Subject: UniStar Nuclear Energy, NRC Docket No. 52-016
Response to Request for Additional Information for the
Calvert Cliffs Nuclear Power Plant, Unit 3,
RAI No. 127, Circulating Water System

**Response to NRC Request for Additional Information
RAI No. 127, Questions 10.04.05-1A and 10.04.05-2B,
Circulating Water System, Calvert Cliffs Nuclear Power Plant, Unit 3**

Figure 1 – Sketch of the CWS Section View (Not to Scale)

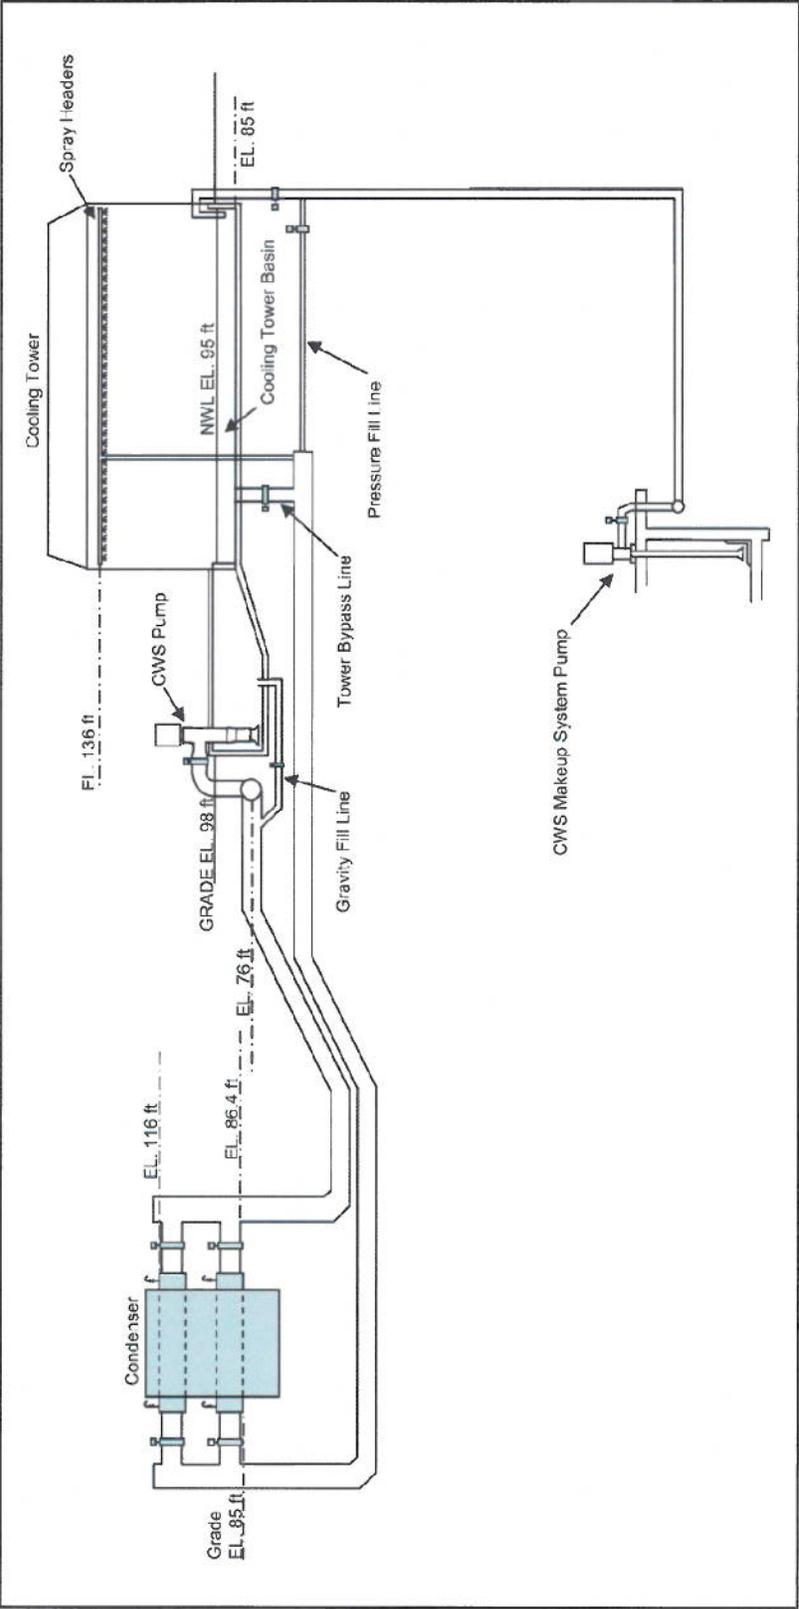
COL Information Item 10.4-6 for the CCNPP CWS states, "if a vacuum priming system is required, a COL applicant that references the U.S. EPR design certification will provide the site specific design information." In CCNPP Unit 3 FSAR Section 10.4.5.2.2, under "Vacuum Priming System," the applicant stated that a vacuum priming system is not required at CCNPP Unit 3; however, the applicant did not provide any justification for its statement. Therefore, the staff requests the applicant to provide additional information and/or clarification in this regard.

For the CCNPP Unit 3 Circulating Water System (CWS), a vacuum priming system is not required either for initial priming of the CWS in preparation for system startup or in maintaining system operation.

The CWS is filled and vented using gravity fill from the circulating water pump forebay and using the pressure fill line with the CWS makeup water system pumps (see Figure 1 below). First, the gravity fill line will be used to prime the Closed Cooling Water System (CLCWS) heat exchangers and fill a substantial portion of the condenser. During this operation, the circulating water makeup pumps provide water from the Chesapeake Bay directly to the cooling tower basin. Next, the pressure fill-line from the CWS makeup system will fill the remainder of the condenser and the rest of the CWS piping. The system is fully primed when fill water exits the condenser waterbox and CLCWS heat exchanger vent valves, and the cooling tower spray nozzles.

During normal system operation, either through the tower spray headers or the tower bypass line, the condenser and heat exchangers are under positive pressure. Therefore no vacuum priming system is required.

Figure 10.4-3 - {Circulating Water System Makeup System P&ID}

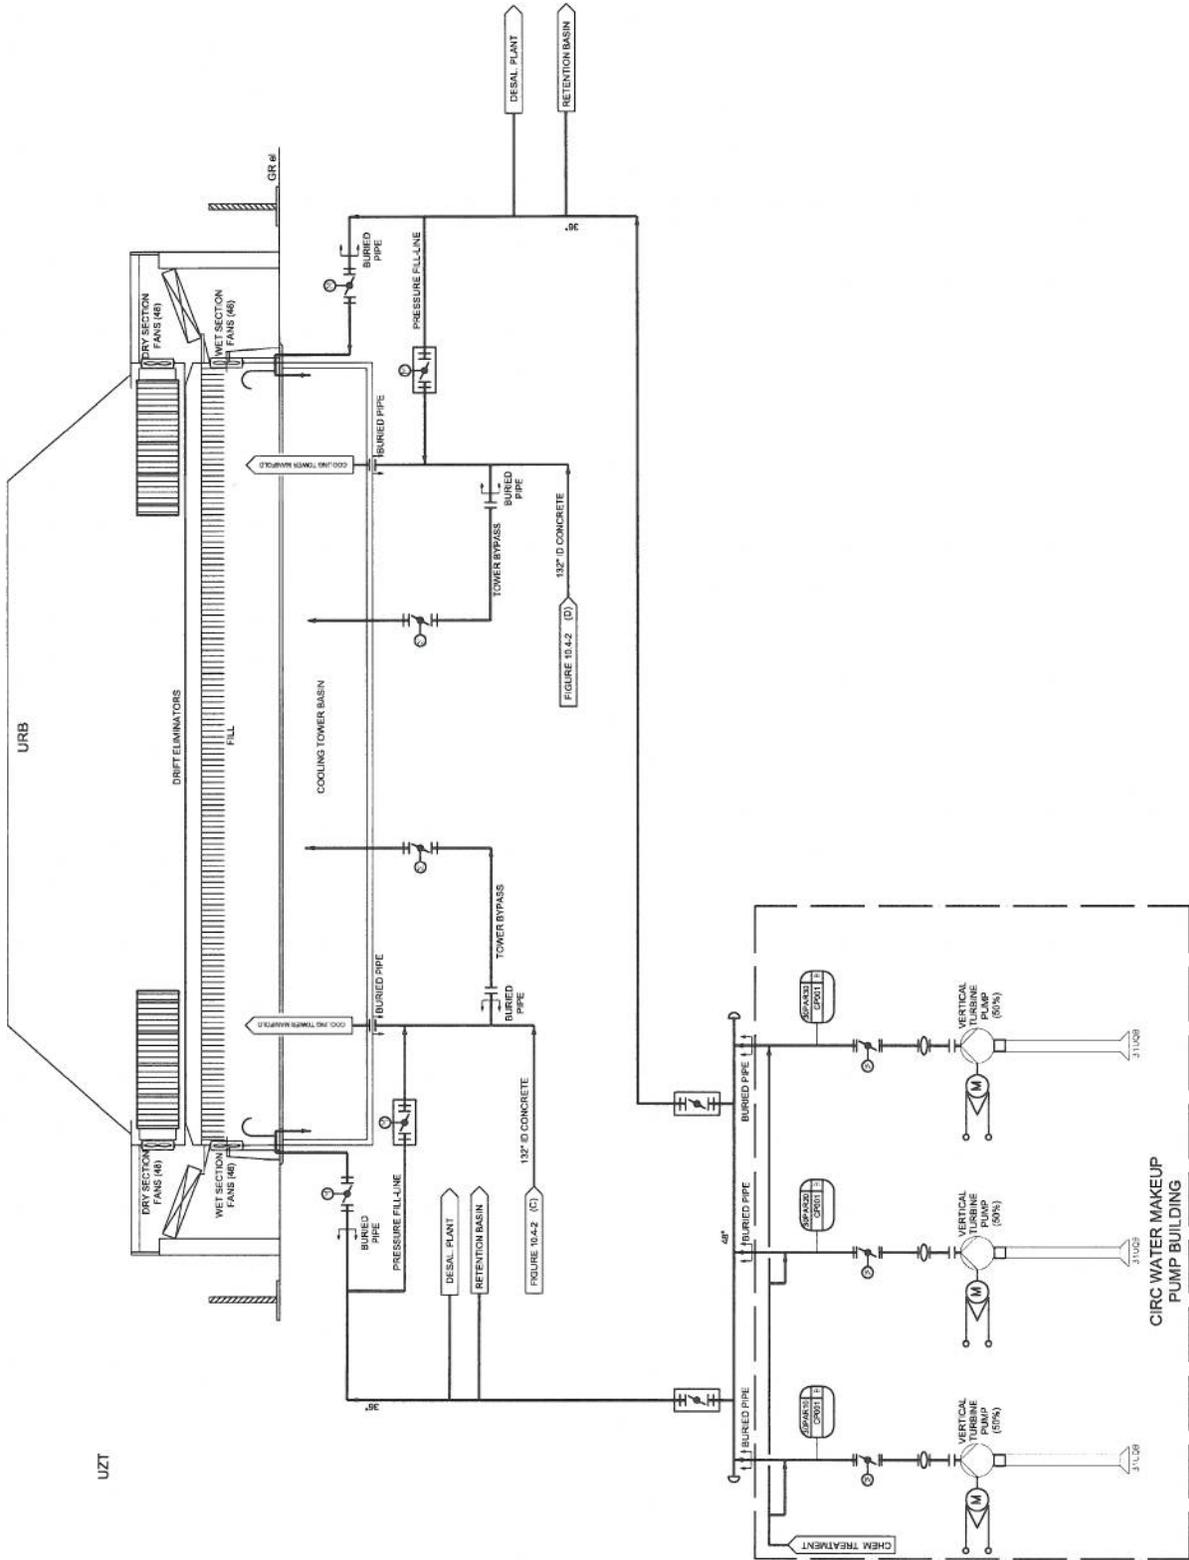
FSAR Figure 10.4-3 will be revised to show the pressure fill line from the CWS makeup water system to the CWS.

FSAR Figure 10.4-3 will be replaced with the following figure in a future COLA revision:
